RE: PCN # ESU270-60 – AQ3118-01ETG additional backend location approval

**Prepared By** : Jordan Hsieh-Product Engineering Manager, Raider Chen-Product Engineer, Sophia Hu-Assistant Product Manager  
**Date** : 2021/2/5  
**Device** : AQ3118-01ETG  
**Revision** : A

**8.0 Changed Part Identification:**

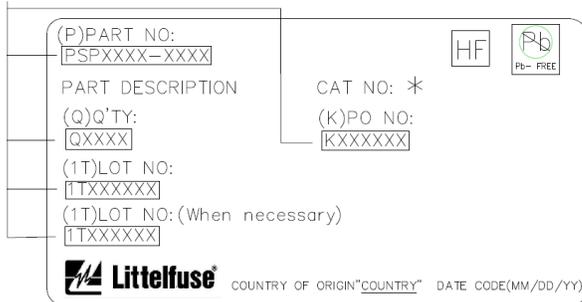
Both were qualified suppliers and it can be identified by code of CAT NO on the label.
